13 CUSHMAN STREET

File P. 38/1947-I

I have your approval on a building permit to cover construction of a one car garage for P. J. Thornton at the rear of 11 Cushman Street.

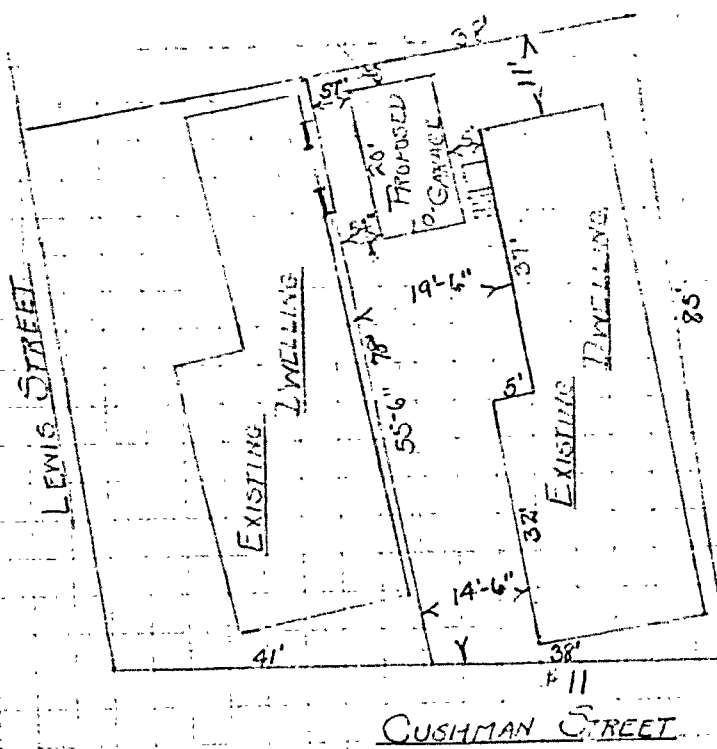
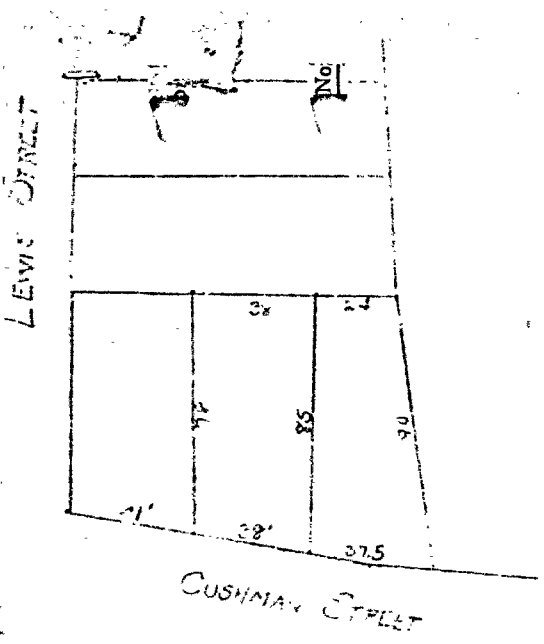
Upon checking the location we find that the wall of this garage would be only 27 inches from two windows in the dwelling house on the adjoining lot.

Thinking that perhaps you were not aware of this condition when your approval was given, I am calling it to your attention. With this information will you please advise whether or not you still want the permit to be issued with your approval on it.
